Form 504	
U. S. DEPARTMENT OF COMMERCE	
COAST AND GEODETIC SURVEY	
DESCRIPTIVE REPORT	
<i>Type of Survey</i> Shoreline(Photogrammetric)	
<i>Field No.</i>	<i>Office No.</i> T-12393
LOCALITY	
<i>State</i>	New York
<i>General locality</i>	Long Island Sound
<i>Locality</i>	Sunken Meadow
<u>19 65 - 1967</u>	
CHIEF OF PARTY	
Allen L. Powell Director, Atlantic Marine Center	
LIBRARY & ARCHIVES	
DATE

COMPILATION REPORT
T-12393

REVIEW REPORT T-12393
SHORELINE
September 12, 1969

T-12393

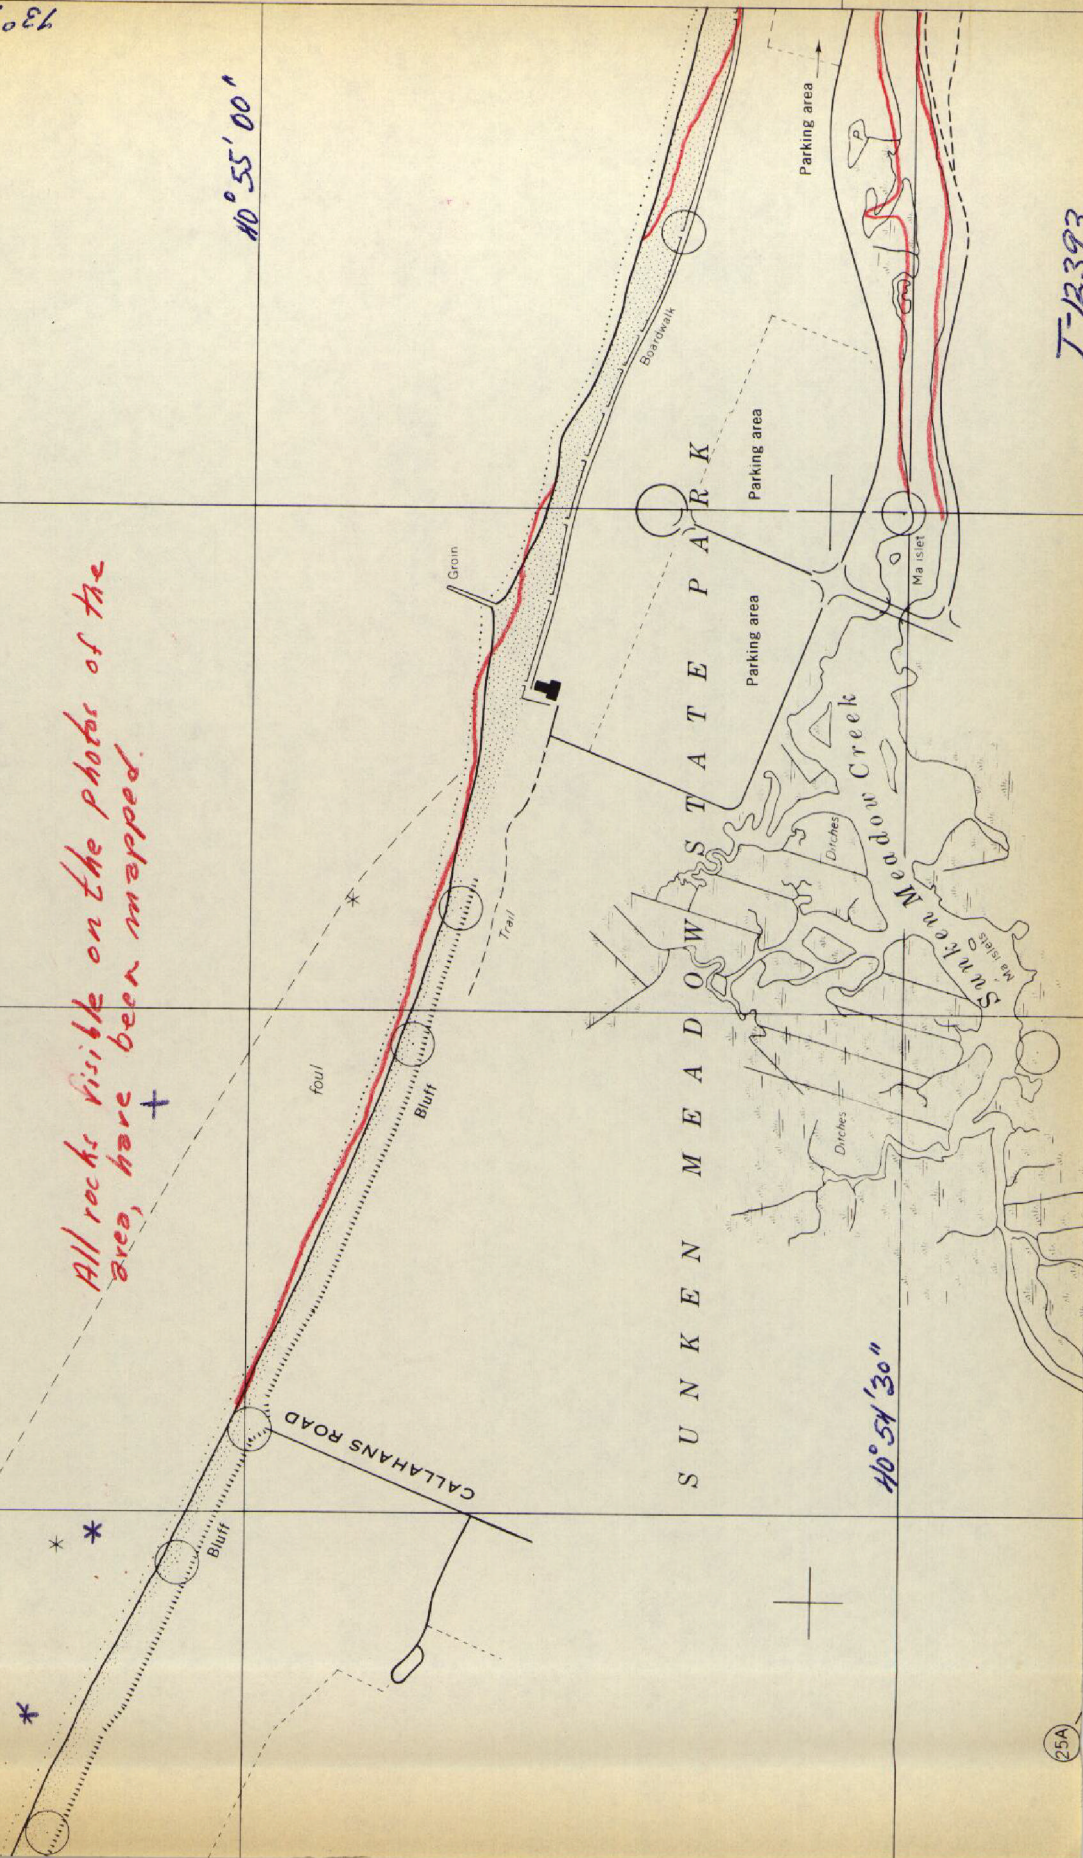
Comparison was made with boat sheet WH-10-2A-67 (H-8950). The shoreline of the two surveys are in agreement, the shoreline of the boat sheet having been obtained from T-12393. All rocks located by the hydrographer that are not visible on the photographs have been indicated on the comparison print in purple.

Comparison was made with Chart 117SC, 8th edition, corrected thru NM43, October 26, 1968. The shoreline of the chart and this survey is in fairly good agreement. The differences that do exist have been indicated on the comparison print in red.

Not all of the rocks shown on the chart were visible on the photographs. Those not visible were also indicated on the comparison print in red.

Probably same rock

Red from Chart 1175C
Purple from WH-10-2A-67 (H-8950)

Note: All rocks that are visible on the photos have been mapped.

All rocks visible on the photos of the
area, have been mapped.
